**PLANNED UNIT DEVELOPMENT
STAFF REPORT****Date: October 4, 2018****DEVELOPMENT NAME**

Springhill Village, LLC

CONTEMPLATED USE

Planned Unit Development Approval to allow multiple buildings on a single building site, with shared access and parking to accommodate two new buildings.

SITE PLAN

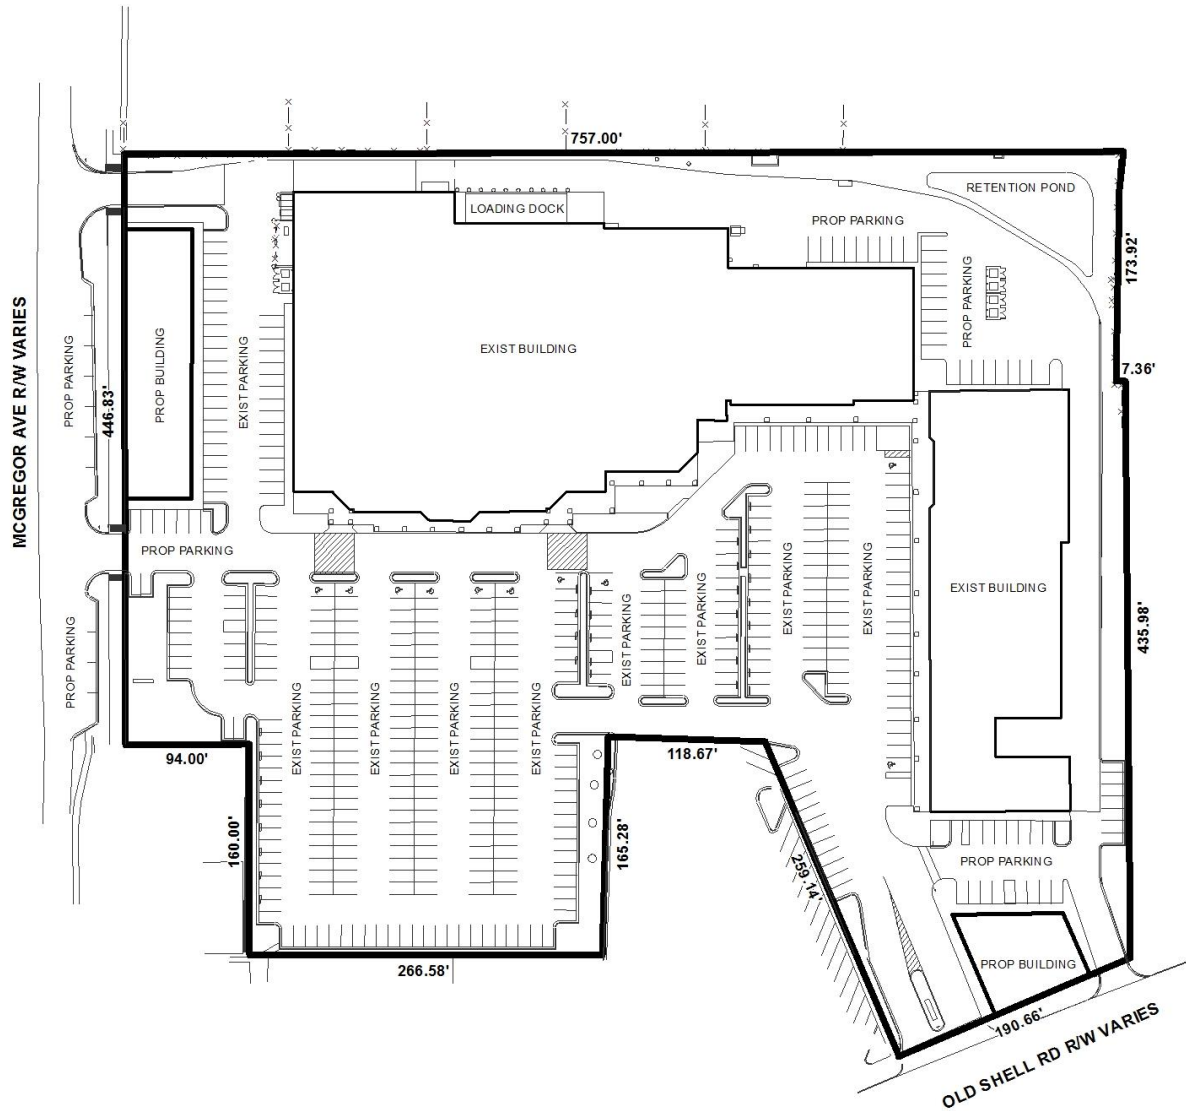
RETAIN NOTES #1 - #7 AS SHOWN ON THE PUD

SITE PLAN.

Revise, as necessary, the existing two (2) dumpster pads to isolate and collect the storm runoff and transport it to the sanitary sewer system.

Site is limited to two curb cuts per street frontage with size, location and design to be approved by Traffic Engineering and conform to AASHTO standards. Any new on-site parking, including ADA handicap spaces, shall meet the minimum standards as defined in Section 64-6 of the City's Zoning Ordinance. Handicap parking spaces on site do not illustrate the required access aisle. Modifications to include the aisles may change the number of onsite parking spaces. The proposed on-street parking should be adjacent to sidewalk so that patrons aren't required to traverse grass/landscaping to access the site. Sidewalk on McGregor Avenue should also be designed to connect to the existing sidewalk on adjacent property to the south. Roadway widening may be necessary on McGregor Avenue to accommodate the relocation of the entrance to the site. Striping modifications will be required to restripe the turn lane to a two-way turn lane, now that the left turns into the site and onto Princess Anne will have to share the same lane to turn left.

The site plan illustrates the items mentioned by the applicant's narrative. The primary focus of the PUD is to allow the two proposed buildings with zero front yard setbacks along both street frontages. The TCD Regulating Plan allows a front build-to line from zero to five feet back from the front property line; therefore, the proposed front setbacks are compliant. The reduced setbacks will also be compatible with existing buildings within the immediate area historically built with reduced front setbacks. The TCD Regulating Plan also requires sidewalks to be a minimum of 12' and a maximum of 15' wide. As proposed, the Old Shell Road sidewalk will be 15' wide, and the North McGregor Avenue sidewalk will be 12' wide. However, as per the Traffic Engineering comments the sidewalk along North McGregor Avenue should be designed to connect to the existing sidewalk on adjacent property to the South.

Although the applicant has requested the PUD be reviewed under the TCD Regulating Plan, there are certain aspects of the site plan which do not follow that plan. Specifically, the building frontage, entry drive width and signage allowances are to note.

The TCD Regulating Plan requires the building frontage in a Village Center Sub-district to be at least 80% of the lot frontage as measured from side property line to side property line at the principal façade line. As the Old Shell Road frontage is 190'±, the minimum building width required is 152'. The site plan indicates the proposed building along that frontage to be approximately 75' wide, or about 40% of that street frontage of the site. Along North McGregor Avenue, the site has 447'± of street frontage, and the proposed building is approximately 200' wide, or approximately 45% (358'± required for 80%) of that street frontage of the site. Therefore, a variance would be required to allow the reduced building frontage along both streets. The site plan should be revised to include a chart of proposed uses and areas with parking calculations based on the above ratios with any fractional spaces rounded up.

The TCD Regulating Plan requires that vehicular parking access drives be a minimum of 24' wide and a maximum of 30' wide for two-way traffic. The site plan indicates the two North McGregor Avenue access drives and the Eastern-most Old Shell Road access drive in compliance with this standard. However, the main divided access drive along Old Shell Road is approximately 65' wide. Therefore, a variance would be required to allow the increased width for this access drive.

The site plan indicates the two existing pylon signs on the site are to remain. However, the TCD Regulating Plan prohibits freestanding signs. Therefore, a Sign Variance would be required to allow the signs to remain.

The site plan does not provide a landscaping or tree planting plan. As the TCD Regulating Plan requires 10% of the total building site being developed or redeveloped to be landscaped, the applicant should revise the site plan to provide a landscaping and tree planting plan meeting compliance. This plan should be coordinated with the Planning and Zoning staff and Long Range Planning prior to submittal.

- 1) approval of a one-lot Subdivision to create a legal lot of record of the site;
- 2) revision of the site plan to provide a chart of parking calculations based on the ratio of one space per 450 square feet of gross floor area for general business uses, one space per 300 square feet of gross floor area for restaurant/lounge area, and no parking required for residential use, with all fractional numbers rounded up;

- 3) approval of a variance to allow the reduced building frontage along both streets;
- 4) approval of a variance to allow the increased access drive width for the divided two-way drive along Old Shell Road;

- 5) approval of a Sign Variance to allow the two pylon signs to remain on site;
- 6) revision of the site plan to provide landscaping and tree planting for 10% of the total site, to be coordinated with the Planning and Zoning staff and Long Range Planning prior to submittal;

- 7) compliance with the Engineering comments: *[RETAIN NOTES #1 - #7 AS SHOWN ON THE PUD SITE PLAN. Revise, as necessary, the existing two (2) dumpster pads to isolate and collect the storm runoff and transport it to the sanitary sewer system.];*

- 8) compliance with all Traffic Engineering comments:
 - a. *Site is limited to two curb cuts per street frontage with size, location and design to be approved by Traffic Engineering and conform to AASHTO standards. (This should also be a note on the site plan).*

- b. *Any new on-site parking, including ADA handicap spaces, shall meet the minimum standards as defined in Section 64-6 of the City's Zoning Ordinance.*

- c. *Handicap parking spaces on site do not illustrate the required access aisle. Modifications to include the aisles may change the number of onsite parking spaces.*

- d. *The proposed on-street parking should be adjacent to sidewalk so that patrons aren't required to traverse grass/landscaping to access the site.*

- e. *Sidewalk on McGregor Avenue should also be designed to connect to the existing sidewalk on adjacent property to the south.*
 - f. *Roadway widening may be necessary on McGregor Avenue to accommodate the relocation of the entrance to the site. Striping modifications will be required to restripe*

the turn lane to a two-way turn lane, now that the left turns into the site and onto Princess Anne will have to share the same lane to turn left.
